**Subject:** Site Plan Review: Rines Forest Parking Lot – Range Road

# SITE PLAN REVIEW APPLICATION RINES FOREST PARKING PLAN CUMBERLAND, MAINE

RINES FOREST PARKING LOT RANGE ROAD CUMBERLAND, MAINE GENERAL NOTES, LEGEND, AND **ABBREVIATIONS**

CONCRETE WHEELSTOP DETAIL

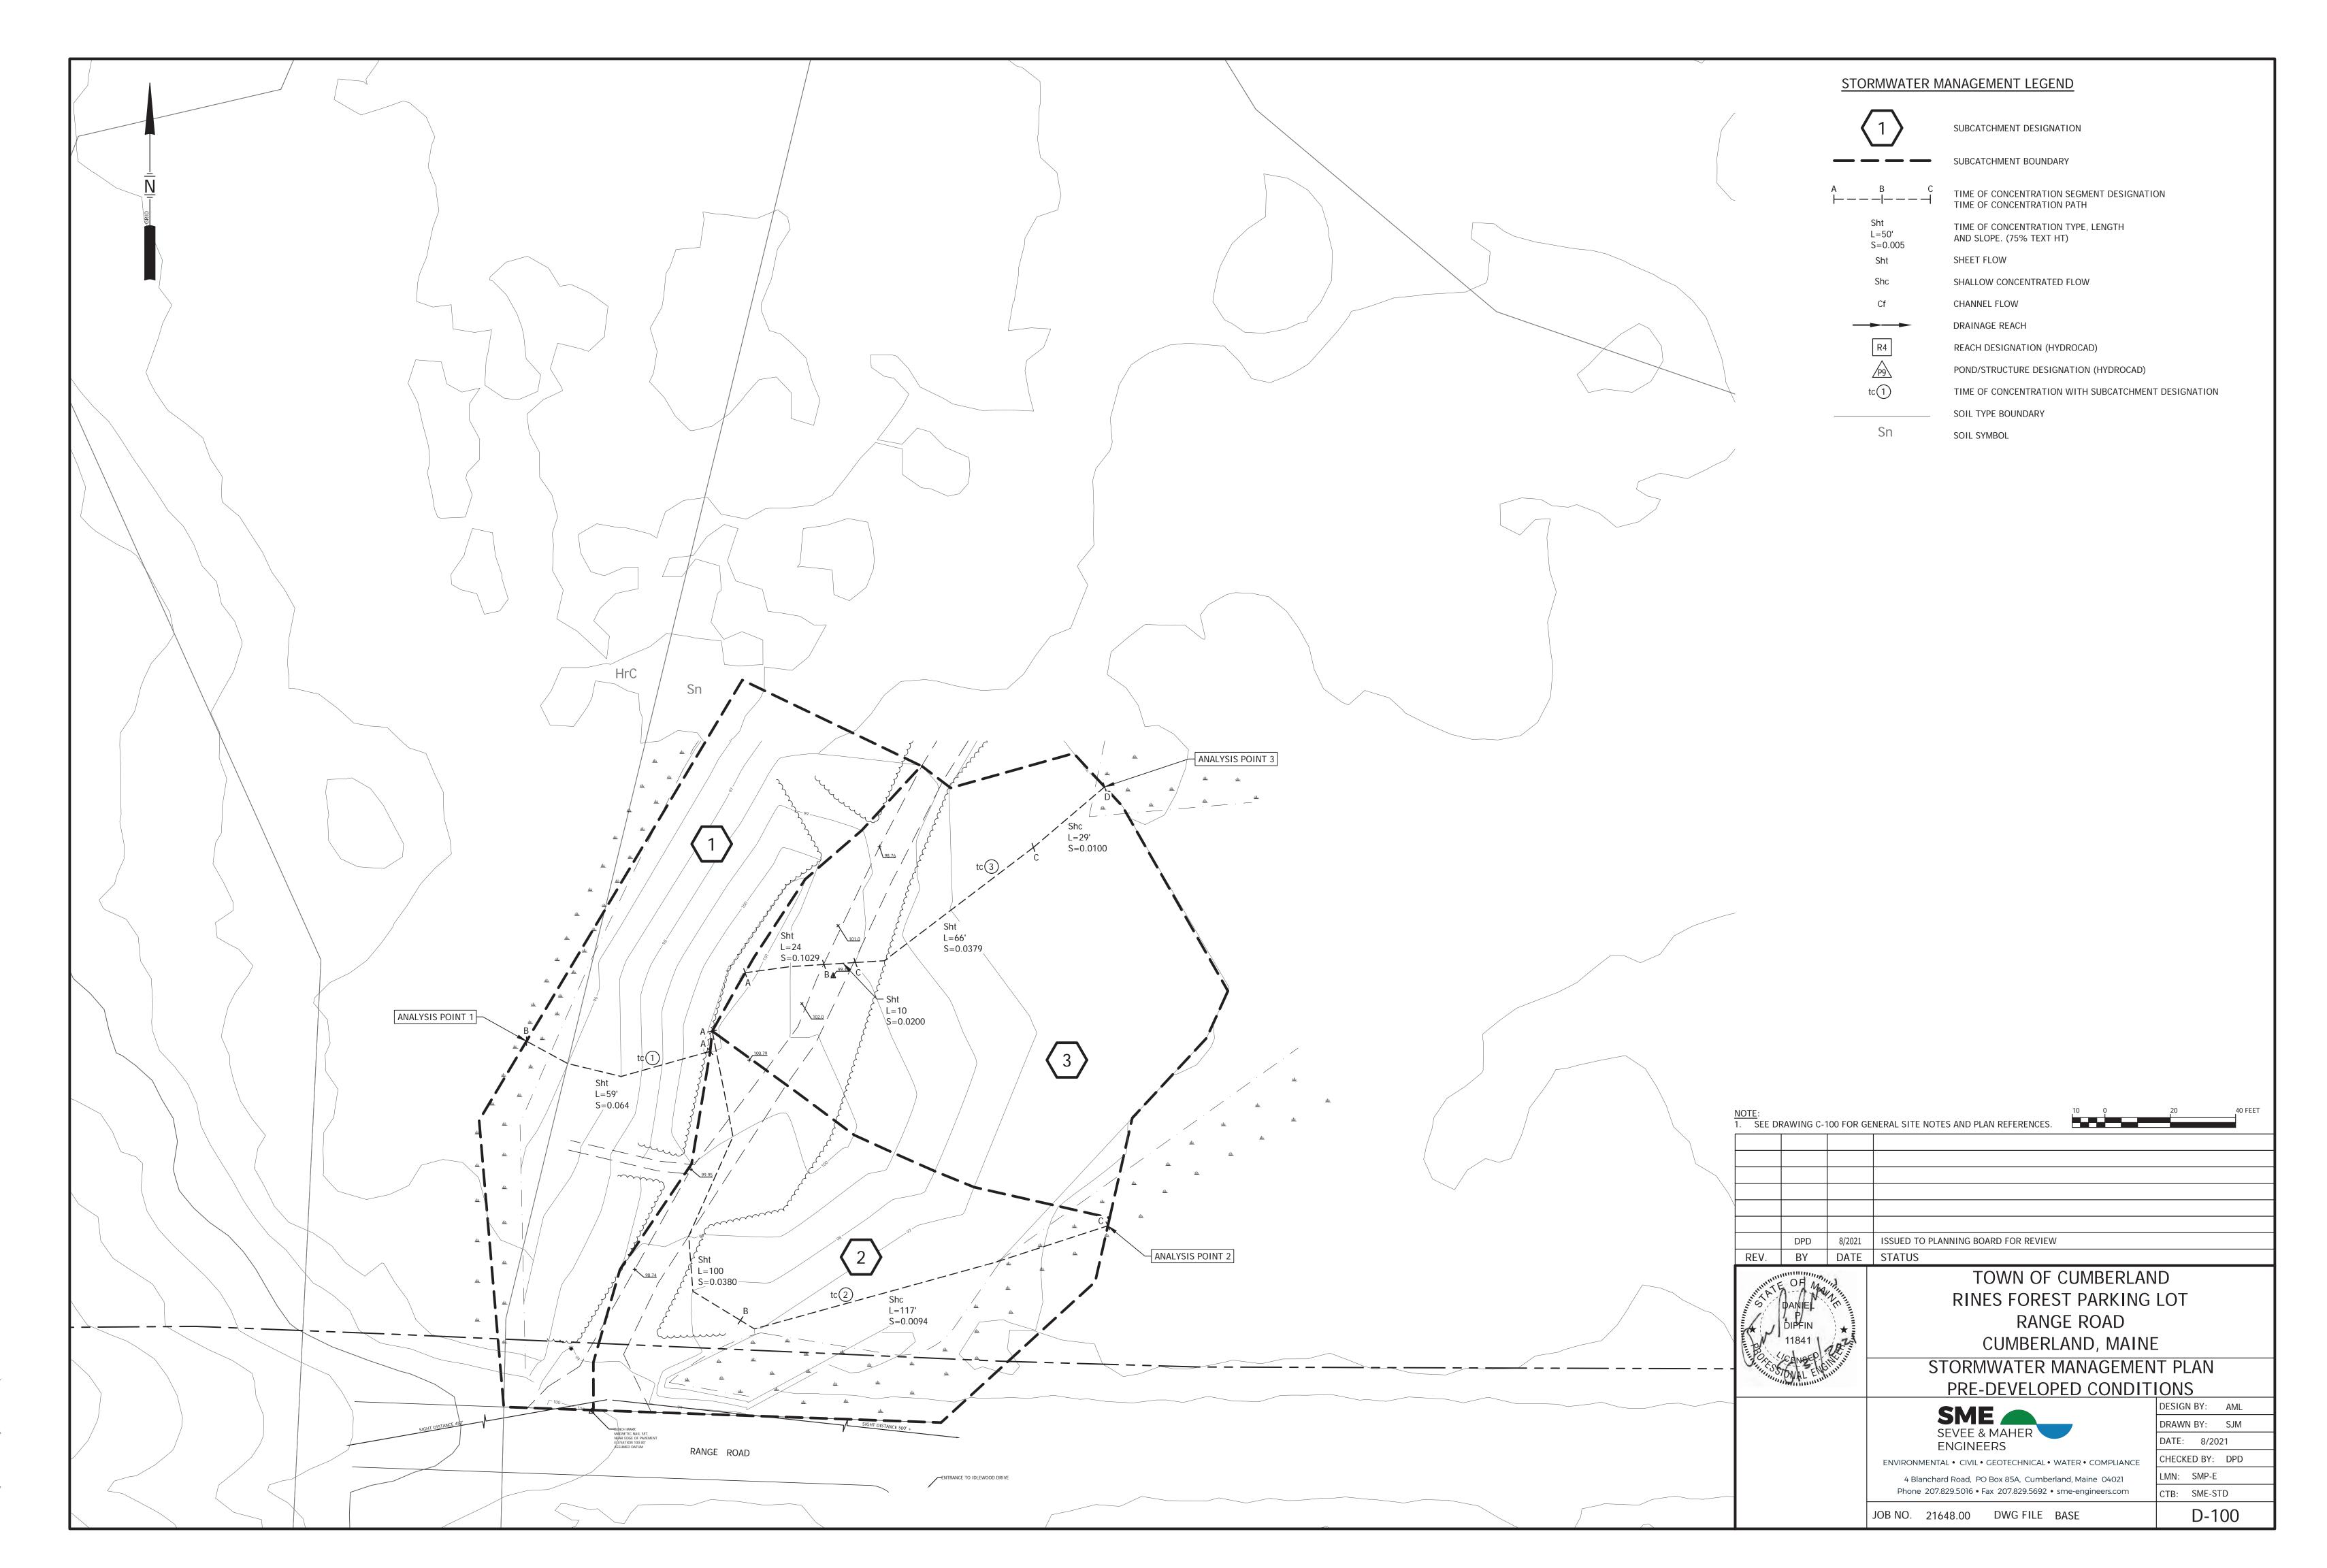
- 11. The Wheel Stop Detail on Sheet C-301 indicates either a 6' or 8' wheel stop. Based on the Site Plan, the wheel stop appears to be 8' in length. Please clarify.
